PD Modification Application: MM 25-0745

Development Services Department

1.0 APPLICATION SUMMARY

8.2 Proposed Site Plan (Page 1 of 6)

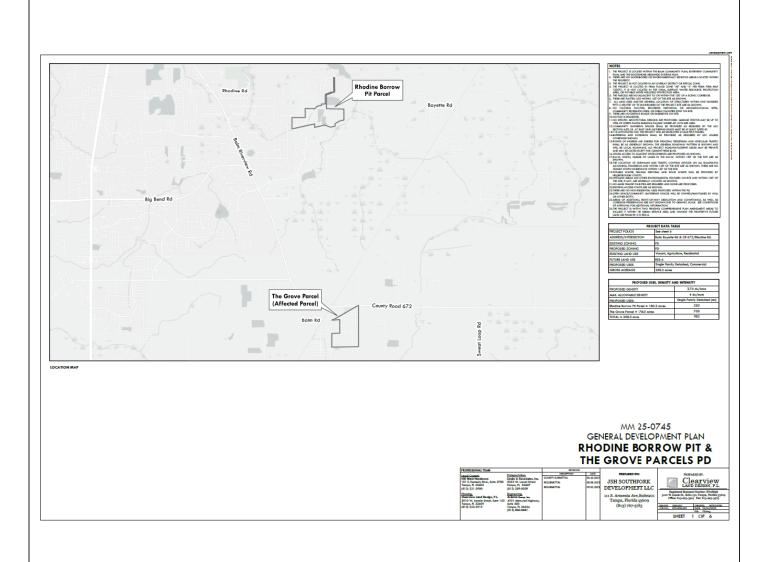
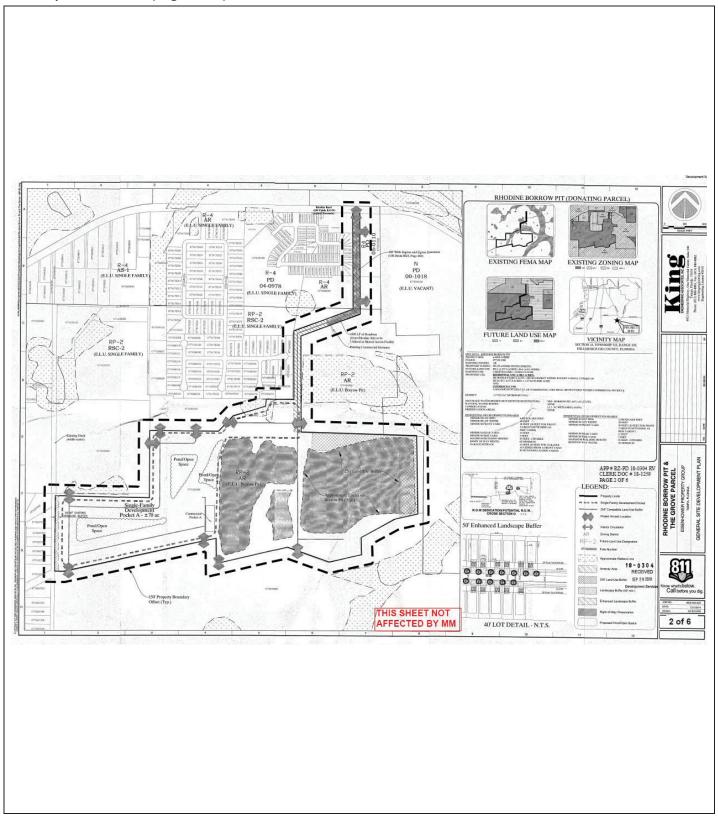
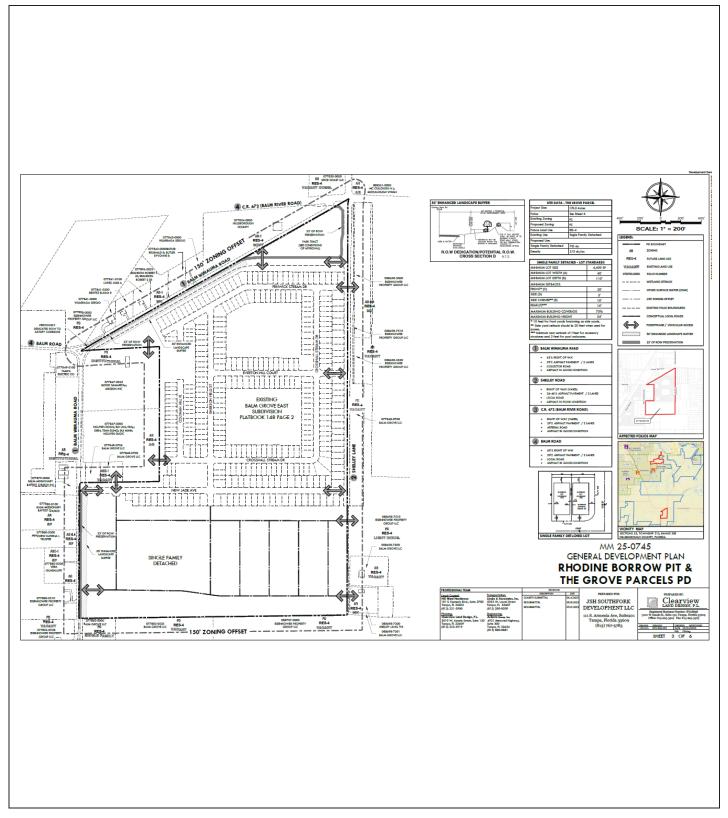
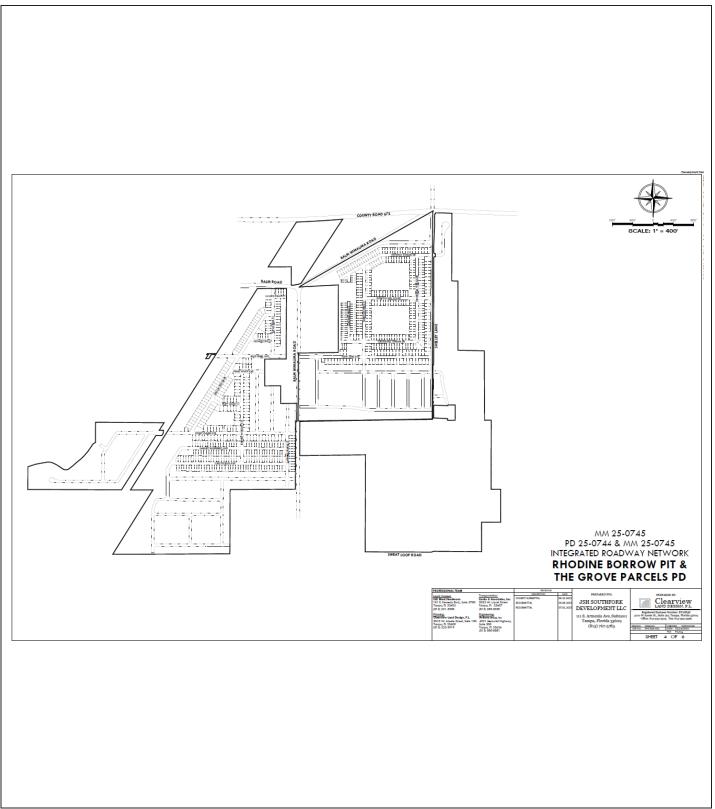
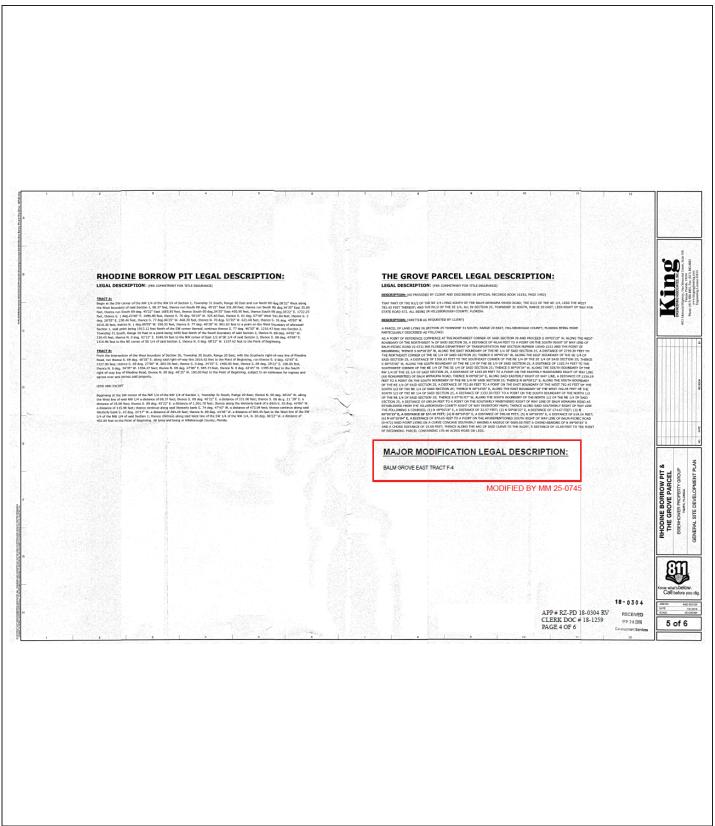
1. Site plan to delineate 50-foot wide buffer in areas previously approved – the Grove Parcel.

- 20.16. A 50-foot wide buffer shall be provided where depicted on the general site plan. Should the buffer be adjacent to a roadway requiring right-of-way preservation, the buffer shall be measured from the future right-of-way line. This buffer is to be platted as a separate tract to be owned and maintained by the Homeowner's Association, or other similar entity. Within the buffer, screening shall be provided and shall be either: 1) screening to consist of two or more of the following for an overall height of six feet: a berm (4:1 slope), a continuous row of evergreen shrubs at a minimum height of 24" and/or a
